Staff Report

PLANNING DIVISION
DEPARTMENT of COMMUNITY and NEIGHBORHOODS

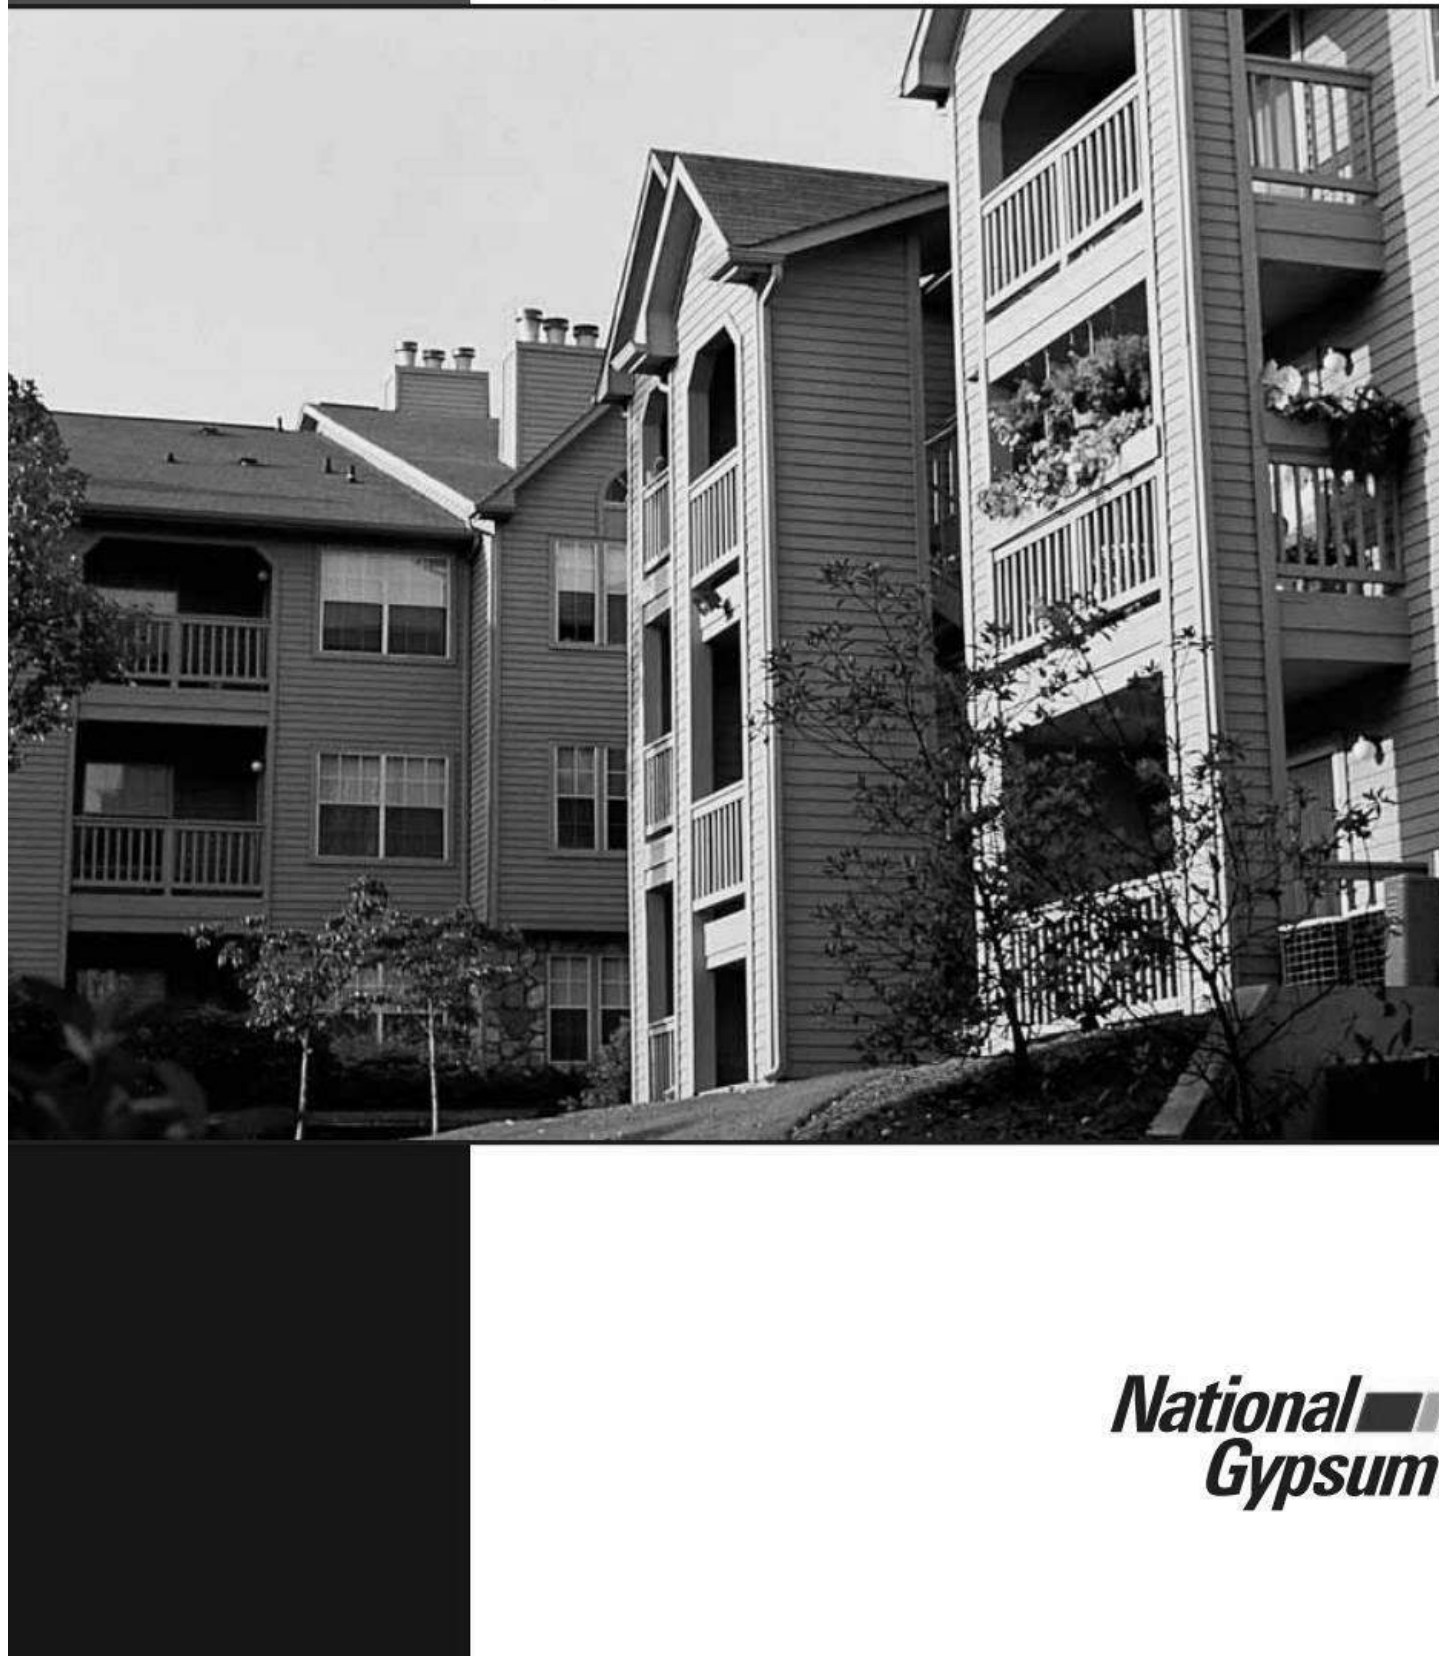
SEE SHEET A3.3 FOR CONSTRUCTION DETAILS AND CLARIFICATIONS OF SHAFT LINER.
